## A NEW VALVE FROM BAUER – AND YOU CAN UPGRADE YOUR EXISTING EQUIPMENT!

Our filling valves have proved themselves in service unchanged for many years. Now, we have further developed the construction.

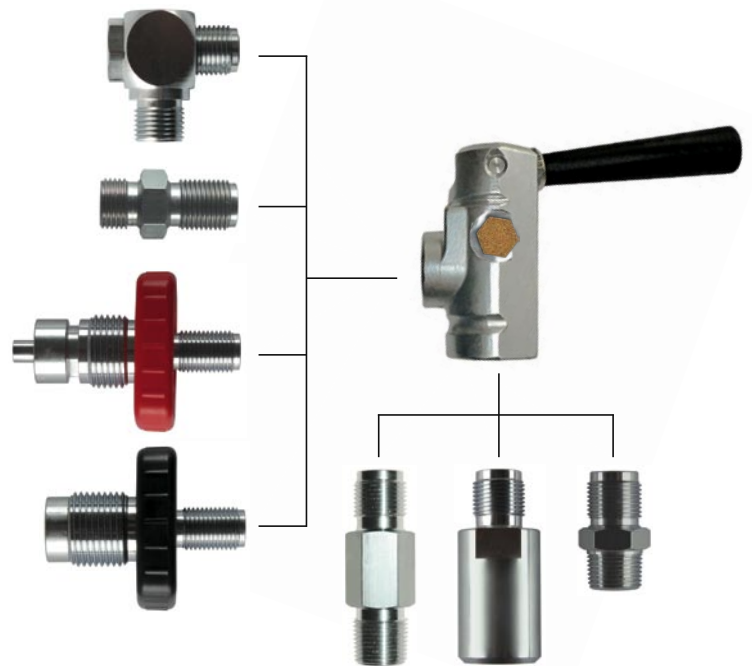
As a result, the valve is now equipped with a venting silencer.

- › The venting noise is reduced by more than half (16 dba)
- › Deep frequency, tuned to the human ear
- › In addition, the minimal residual noise and the excess air can be externally vented via a G1/8 connection
- › Fully backwards compatible, all-round exchangeable and many component parts separately obtainable
- › Adapted servicing kits immediately available
- › Absolutely corrosion-proof
- › Permanent lubrication
- › Suitable for continuous use
